IFB No. **17-36 Flinn Middle School HVAC, Lighting and Ramp Renovations**

RE: **ADDENDUM NO. 5**

PROJECT: FLINN MIDDLE SCHOOL HVAC, LIGHTING AND RAMP RENOVATIONS
ROCKFORD PUBLIC SCHOOLS 205
ROCKFORD, ILLINOIS

PROJECT NO.: 25109

1 BOILER ROOM LOWER LEVEL REVISED PLAN
SCALE: 1/4" = 1'-0"

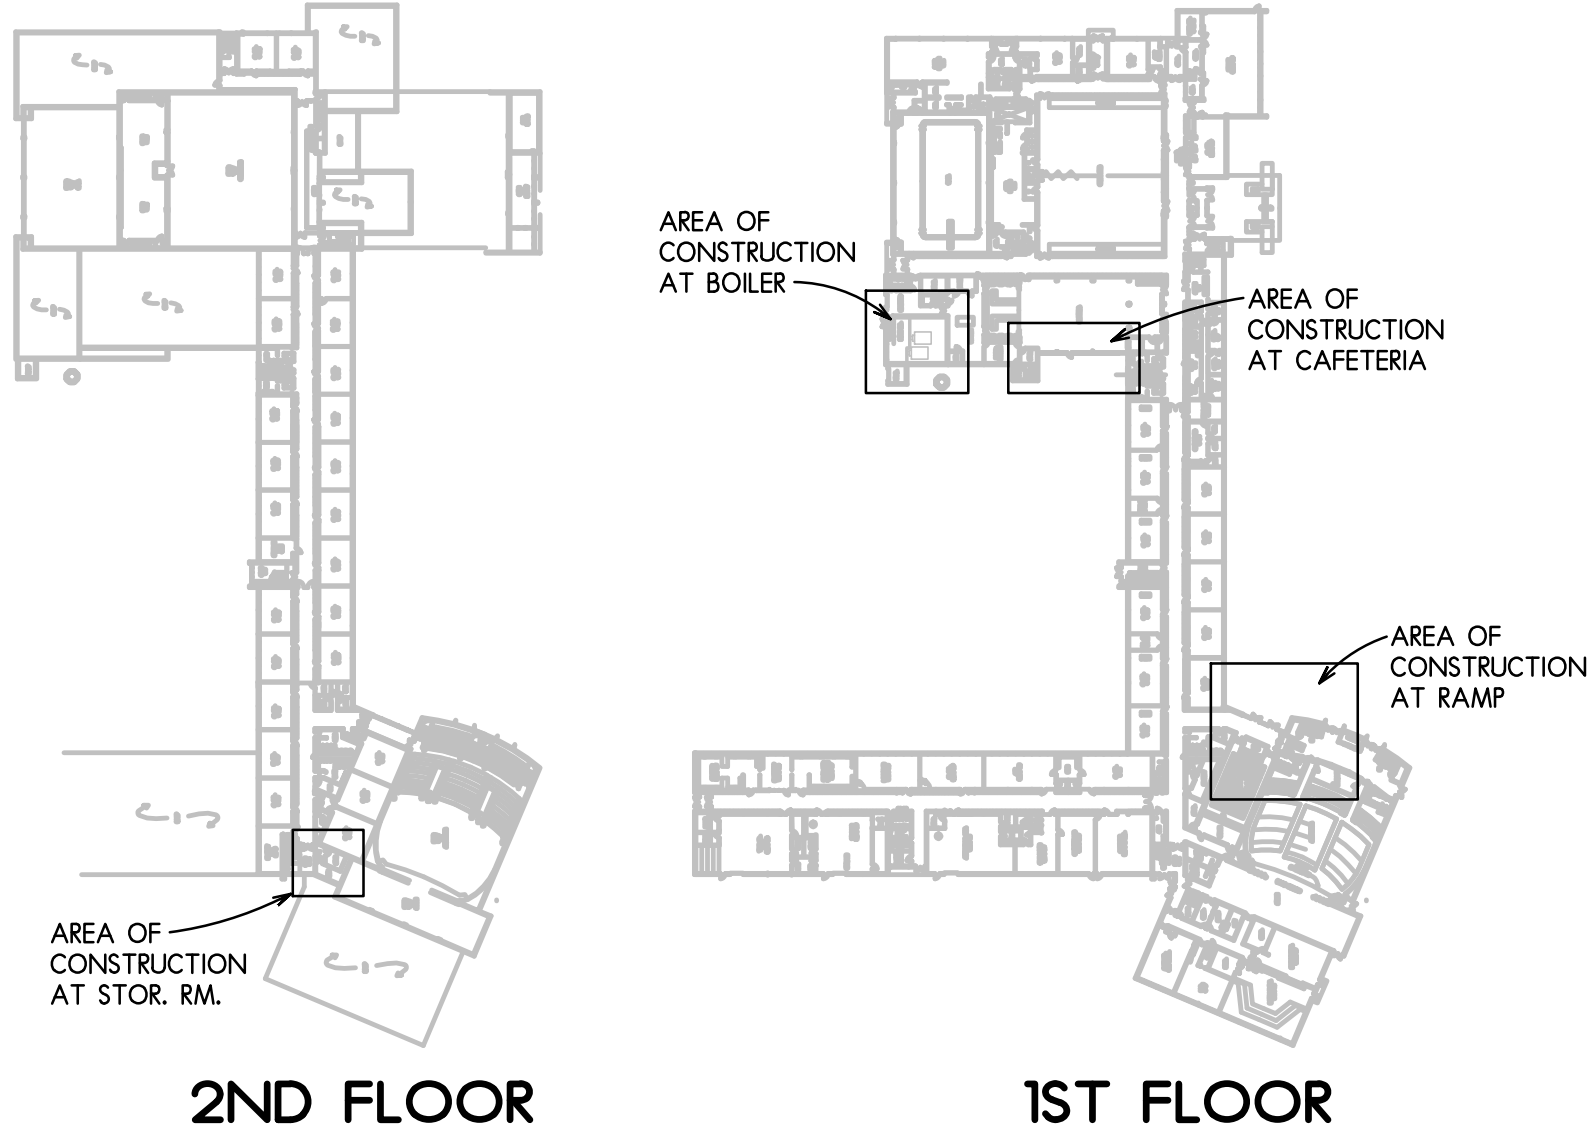
- A. An allowance for Boiler Room concrete slab and plumbing work is to be provided. Scope of work is listed below.
1. Present floor drain within boiler room discharge to the storm sewer system. To repipe to the sanitary system provide allowance for the following work.

- a. Remove (6) present floor drains within boiler room. Remove or abandon associated piping.
 - b. Provide (5) new 4" floor drains at approximate locations of removed drains, note (1) drain does not need replacement. Each drain shall be provided with p-trap and associated vent system. Drains shall be routed to new pump system in northeast corner of room.

- c. Pump system shall be 48" diameter x 48" deep fiberglass pump basin with (2) Weil model 1413 (or equivalent), 1 HP pumps with (4) float switches and control panel with high water alarm.

- d. 2" Pump discharge shall be routed to present 4" overhead sanitary sewer line in adjacent tunnel.
 - e. The existing gridded footing tile system below the shall be avoided where possible. If damaged it shall be patched as necessary to maintain a functioning system.

- f. New sanitary sewer and vent piping shall be cast-iron with gasketed joints.
- g. Pump discharge piping shall be galvanized steel or schedule 80 PVC.
- h. New floor drains shall be Zurn No. Z-550-Y or equivalent.
- i. New floor cleanouts shall be Zurn No. ZN1400-HD or equivalent.
- j. Cutting and patching of present floor slab shall be included.
- k. Supplemental drawing will be issued after award of contract to detail work described above.
